## BICYCLE No. 3

### TECHNICAL COMMITTEE RECOMMENDATION

**TOPIC:** Revision of Use of Bicycle Lane Signs  
Part 9 of the MUTCD

R3-17

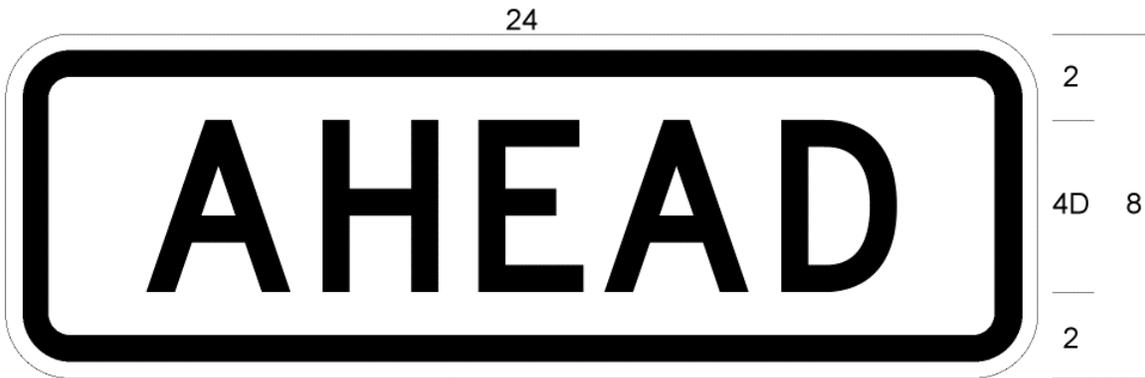
The Bicycle Technical Committee also proposes to change the minimum size of the R3-17 sign to 24" x 18" (600 mm x 450 mm), and to change the minimum size of the R3-17a and R3-17b to 24" x 8" (600 mm x 200 mm). It was the original intent of the NCUTCD Bicycle Technical Committee to establish these sizes as the minimum sizes in the 2003 MUTCD, but this was inadvertently overlooked during rulemaking. This will result in the minimum R3-17 size being consistent with the current size of the D11-1 BIKE ROUTE sign. The 24" x 18" size should provide more than adequate visibility at typical arterial traffic speeds, and can better fit in restricted locations in urban environments.

Bike Lane	R3-17	—	<del>750600 x 600450</del> <u>(3024 x 2418)</u>
Bicycle Lane Supplemental Plaques	R3-17a,b	—	<del>750600 x 300200</del> <u>(3024 x 128)</u>

The BIKE LANE (R3-17) sign, if used (see Figure 9B-2), shall be used only in

conjunction with marked bicycle lanes as described in Section 9C.04, ~~and shall be placed at periodic intervals along the bicycle lanes.~~

Bicycle Lane signs (R3-17, R3-17a and R3-17b) should be used in advance of the beginning of a marked bicycle lane, at the end of the bicycle lane, and at periodic intervals.

The AHEAD (R3-17a) sign (see Figure 9B-2) should be mounted directly below a R3-17 sign in advance of the beginning of a marked bicycle lane.

The ENDS (R3-17b) sign (see Figure 9B-2) should be mounted directly below a R3-17 sign at the end of a marked bicycle lane.
